22-48SP Laurel Rick Johnson Tire & Auto Staff Report

Address:	301 Serano Way
Requests:	Request to construct an 8-bay tire and auto center
Owner:	RAJ Store 23, LLC
Agent:	Boreal Engineering & Design, LLC
Parcel ID:	0376130100
Parcel Size:	.95 ± acres
Future Land Use:	Mixed Use Corridor (MUC)
Zoning:	Laurel East
Comprehensive Plan Neighborhood:	Laurel Road
Application Date:	July, 27 2022

Site and Development Plan

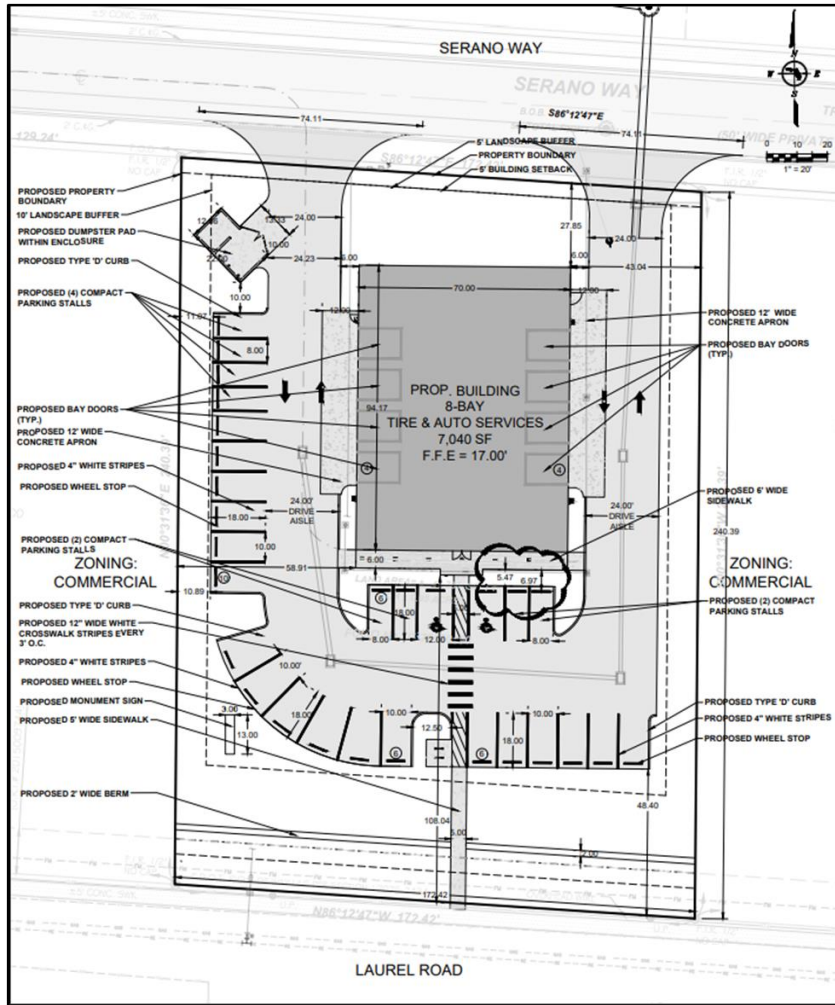
Staff Comment: Mixed Use Districts are deemed to be internally compatible and do not require compatibility setbacks or additional buffering standards unless required in Section 4.5: Mixed Use Considerations. Under Section 4.5 Mixed Use Considerations a buffer type 3 would be required along Laurel Road, though in the case of this Petition the proposed site is within the Portofino CMU and buffering requirements outlined in the CMU for Laurel Road have been met.

Staff Comment: Access would be provided from two points off Sereno Way and would provide access from the Tire and Auto Store to the pedestrian walkways along Laurel Road on the south side of the property.

Staff Comment: The CMU states "The property owner reserves the right to determine the appropriate number of spaces based on specific tenants and to propose an alternative parking standard based on a parking study at the time of each site and development plan review and may exceed these minimum provisions to accommodate design, projected uses and tenant requirements." Applicant has provided a Parking Study which demonstrates that the parking provided is appropriate to accommodate design, projected uses and tenant requirements. Additionally, the parking provided meets the parking standards for 'minor vehicle services' outlined in the LDRs.

Architectural Elevations

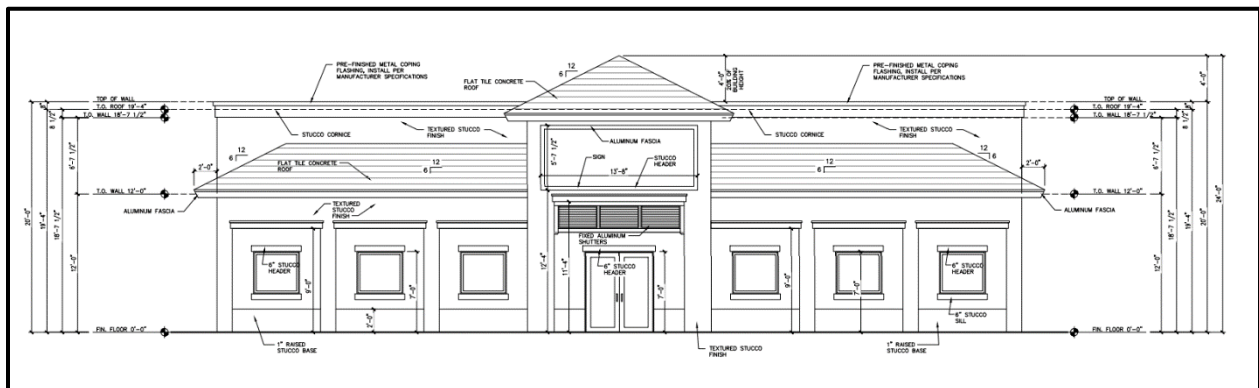
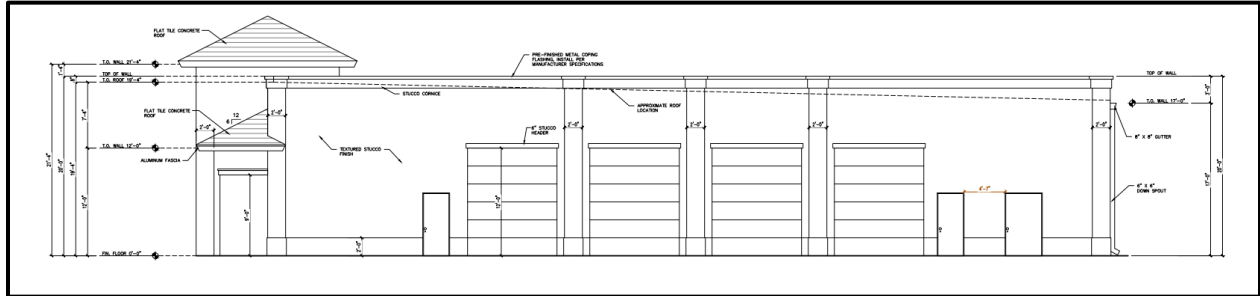
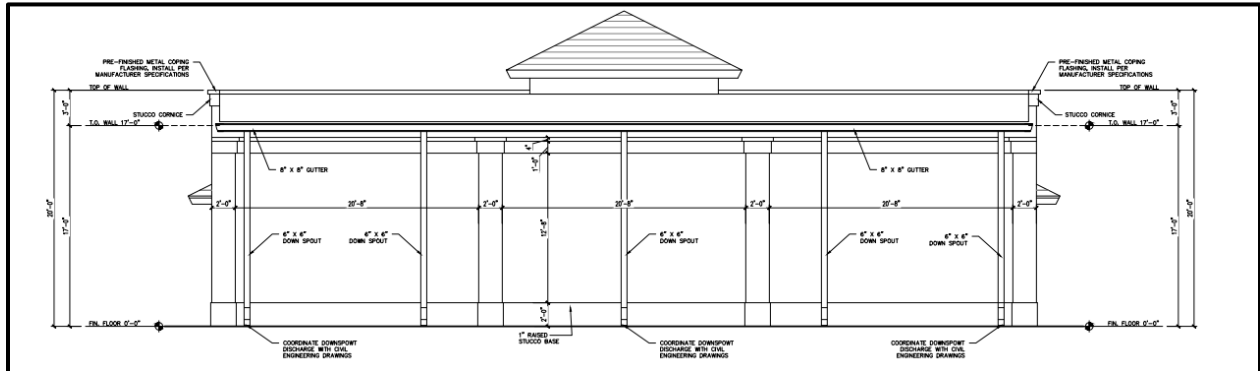
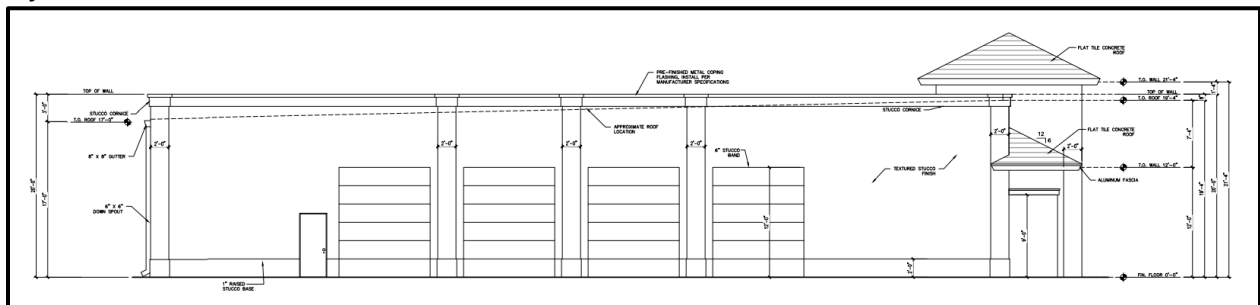
Staff Comment: Northern Italian Renaissance architectural elements are provided on the building and the architectural design is consistent with requirements of the Portofino CMU. Design is also consistent with similar design features of recent petitions approved in the surrounding proximity.
